STAFF REPORT: 02-10-2021 MEETING

APPLICATION NUMBER: 21-7050

ADDRESS: 1201 WASHINGTON BOULEVARD

SCOPE: DEMOLISH PORTION OF BUILDING AT REAR; REPLACE NON-HISTORIC STOREFRONTS, ROOFTOP ADDITIONS

WASHINGTON BLVD PROPOSED ELEVATION

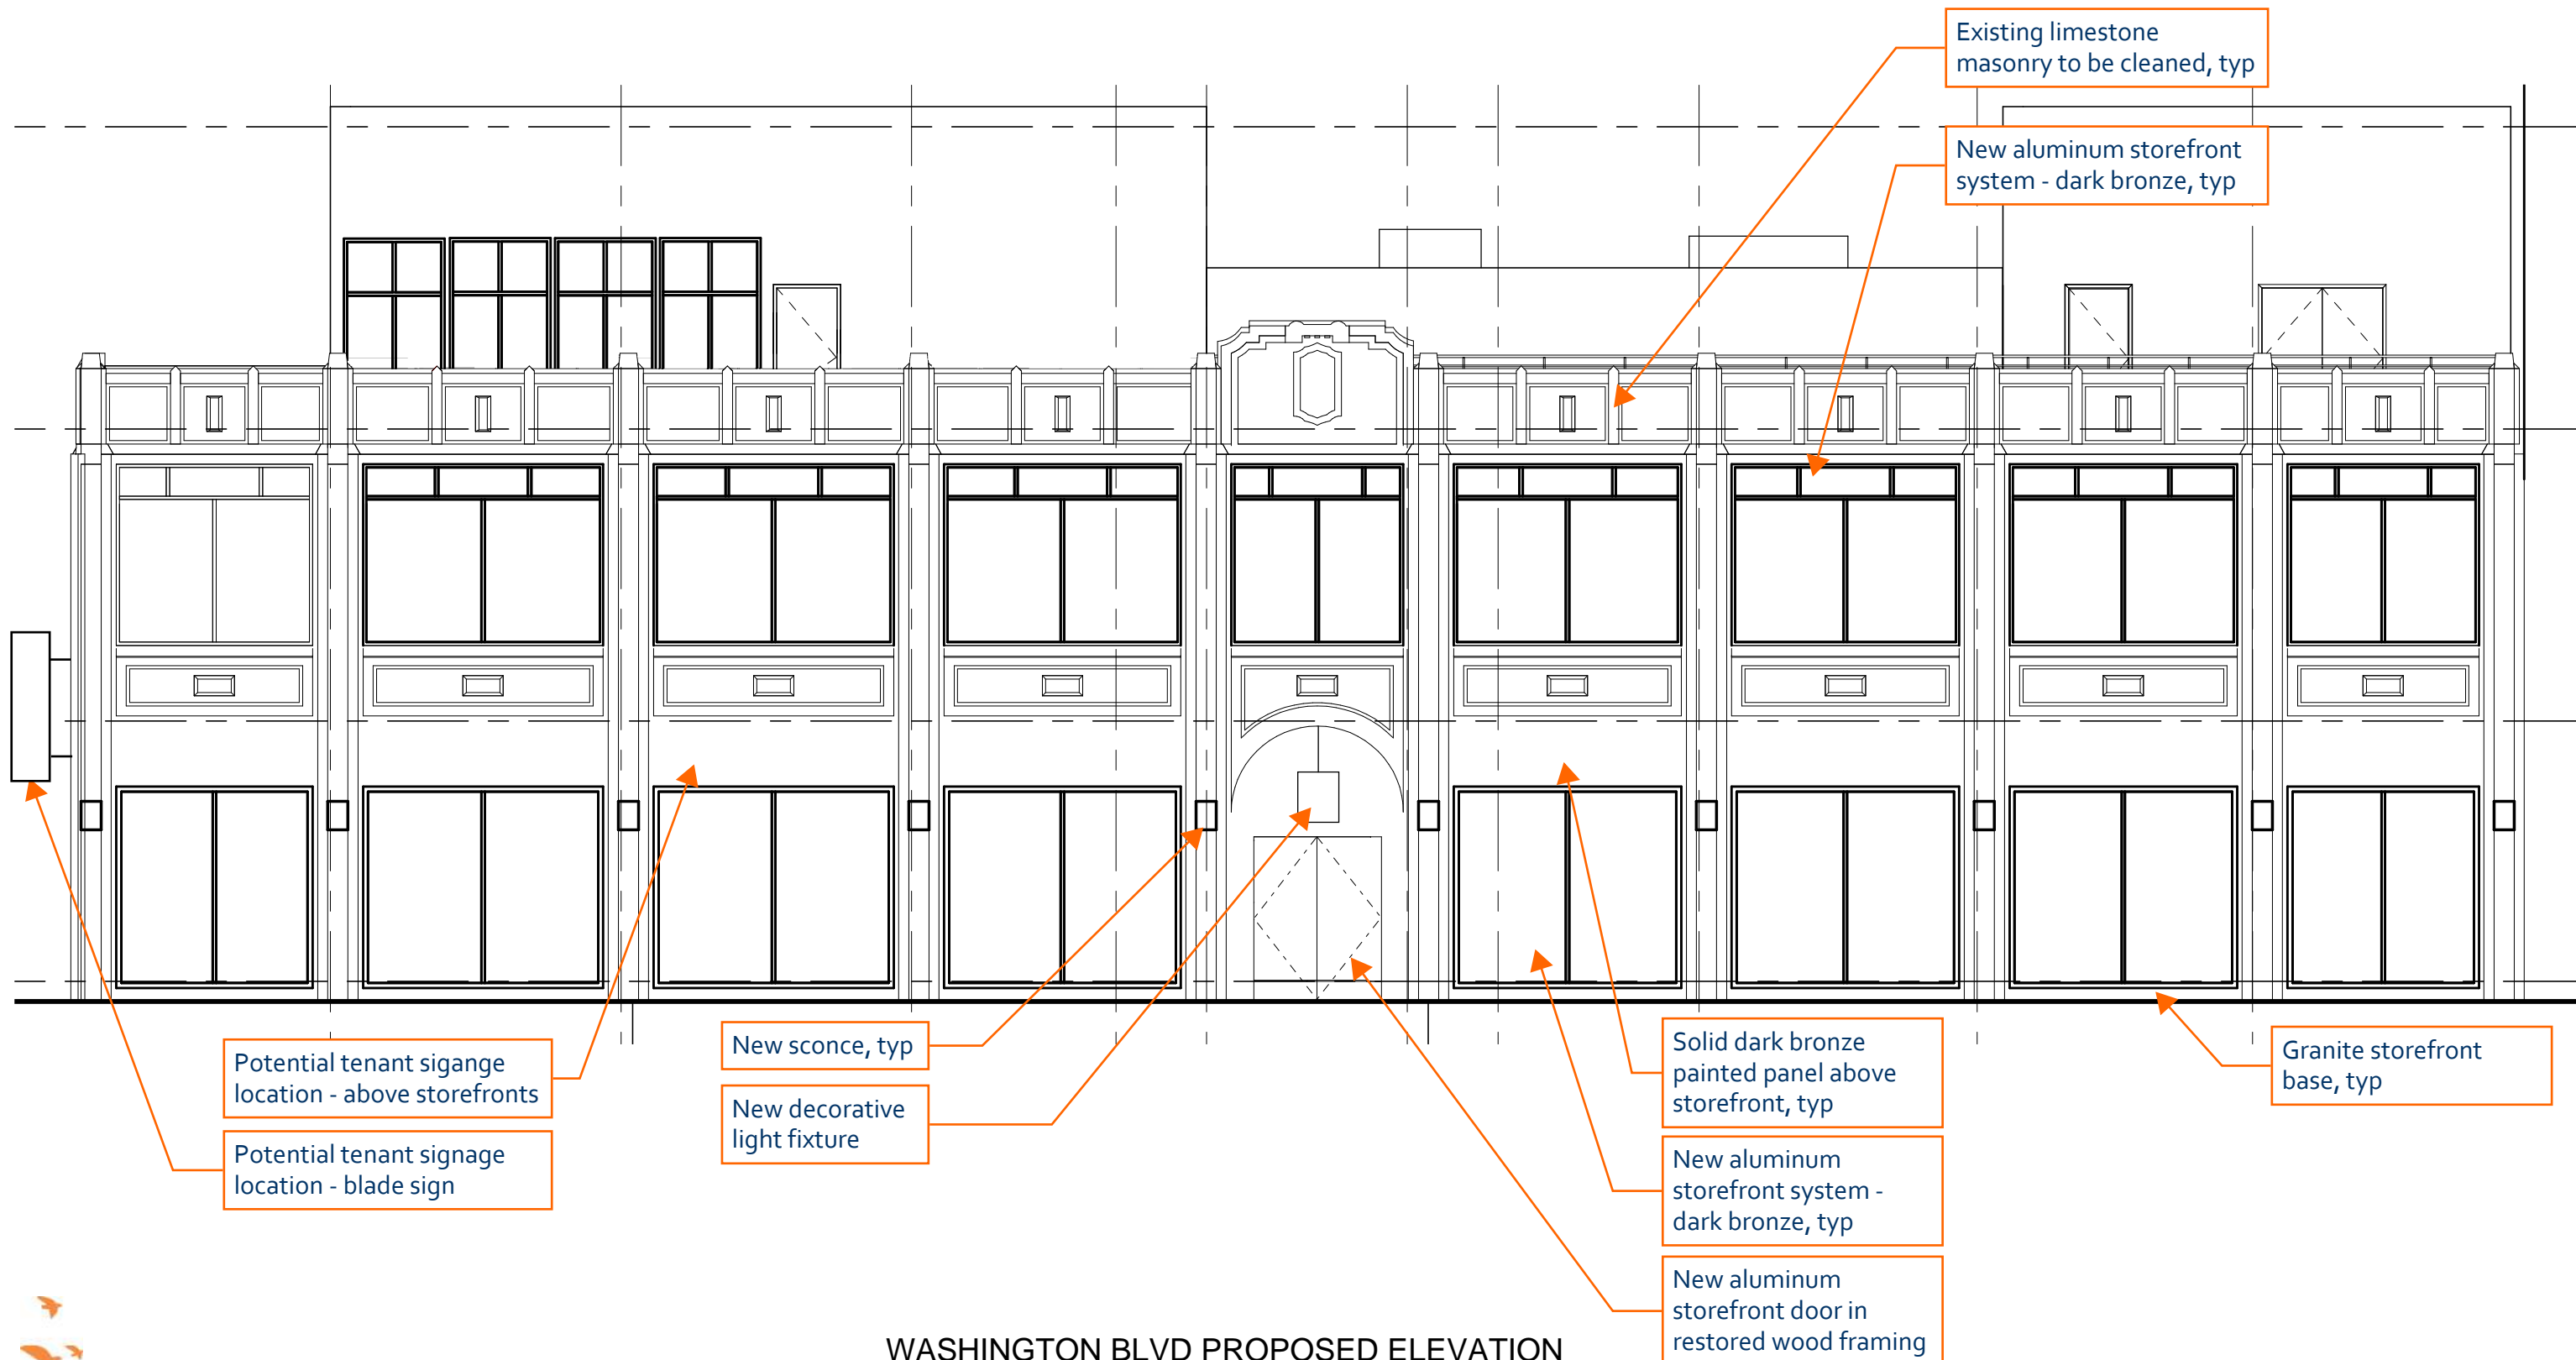
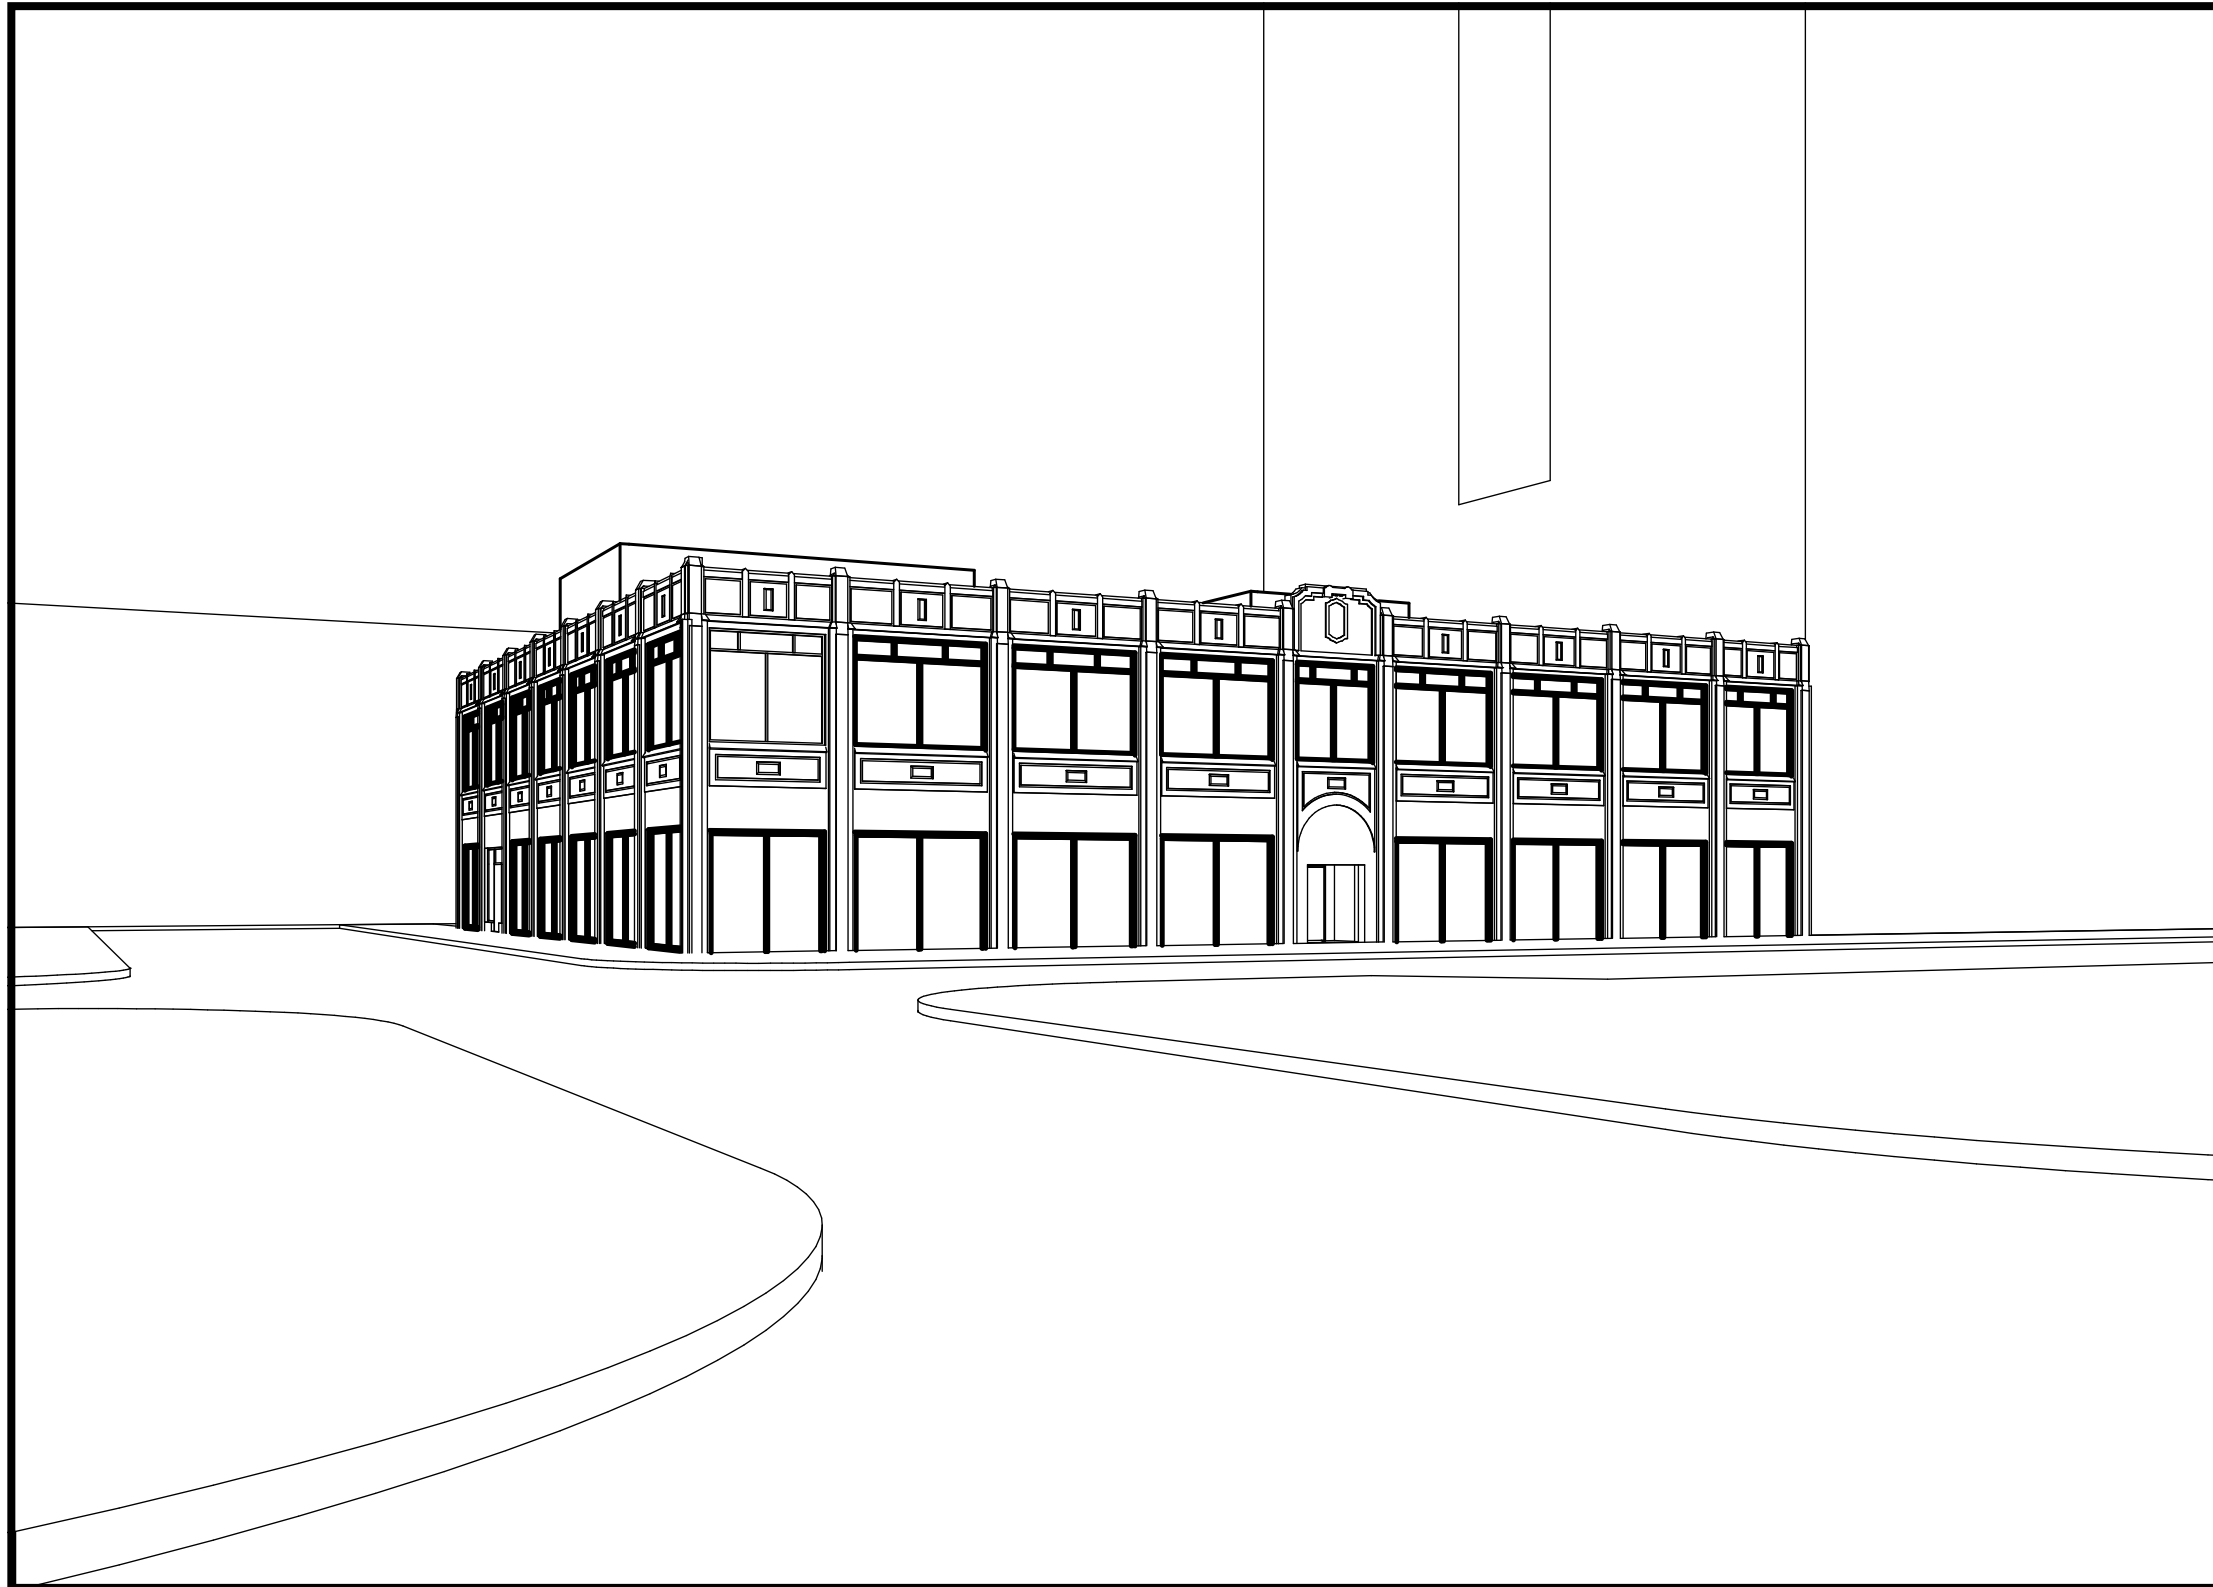
- Aluminum-framed storefronts are in place on the first and second floors. All non-original exterior storefronts will be removed and replaced. *Needed: Details/catalog cuts of the proposed storefront system.*

- Large format storefront windows, divided by a thin mullion at the center point, will be installed in the storefront spaces.
- The non-historic paneling above the storefronts will be removed, and the new storefronts will be 10' high with a metal panel for signage between the storefront head and the bottom of the limestone. *Needed: Dimensions, material, finish, color, and wall section showing how the panels will be installed within the greater storefront openings.*
- Additional doors for tenant access if the 1st floor is leased by multiple tenants will be centered within the bay, as shown on the attached alternate elevations. *Needed: Catalog cut of the door.*

- Main double door entrance will remain in center bay. The double doors are glazed with an arched transom overhead that is divided into three lights. *Needed: A door detail/elevation/catalog cut.*

STATE ST PROPOSED ELEVATION

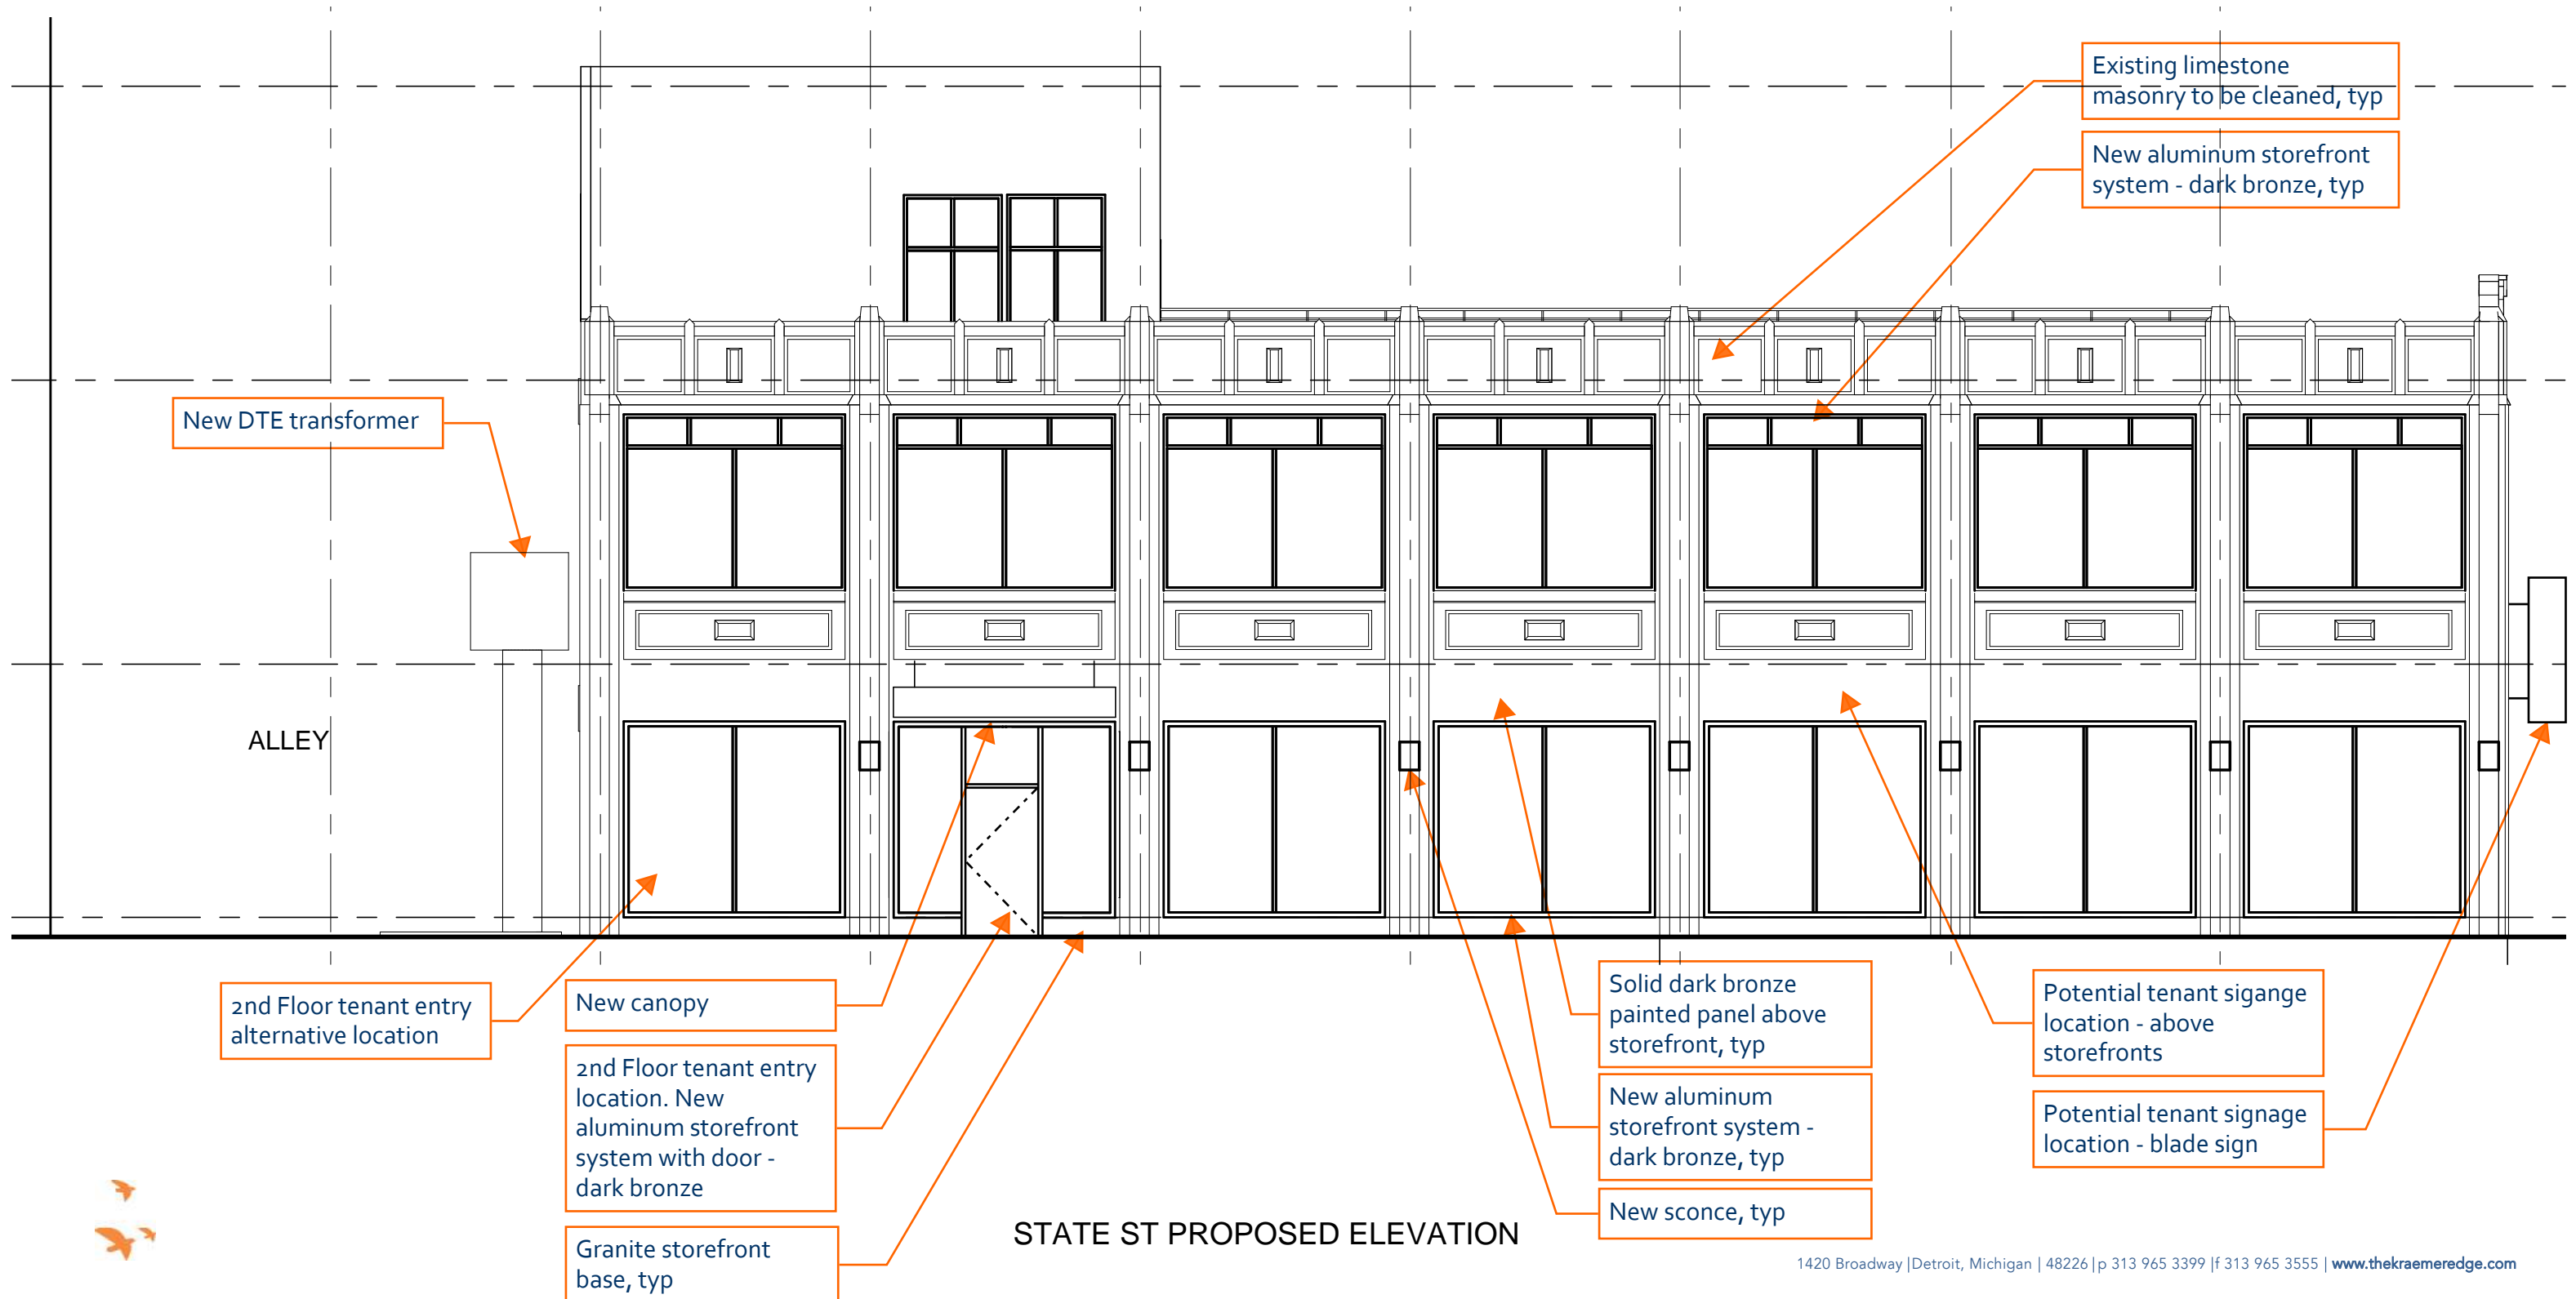
- One of the two western-most bays will receive an entry door into a lobby for the 2nd floor tenant. This new entrance door will be glazed and centered within the new storefront window with sidelights on either side of the door and a transom overhead. A simple metal canopy will be installed over this storefront bay to provide shelter as tenants enter and exit the building. *Needed: Canopy details/installation section and entrance door catalog cut.*

- The submitted drawings of the proposed storefronts (including sign panels), entry door, and penthouses offer a framework of the building's rehabilitation but lack design details (wall sections, detailed elevations, catalog cuts, etc.) necessary for the HDC's review. Therefore, staff recommends the Commission not consider items beyond the proposed partial demolition and the applicant come back to a future meeting with a detailed proposal for all of the elements related to the building's rehabilitation.
- Regarding the proposed demolition, it is staff's opinion the applicant has not exhausted its options for loading zone variances. Staff questions whether historic buildings, confined to existing street patterns and adjacent buildings, can be offered even greater leeway in the number of required loading zones. For instance, what if 1201 Washington
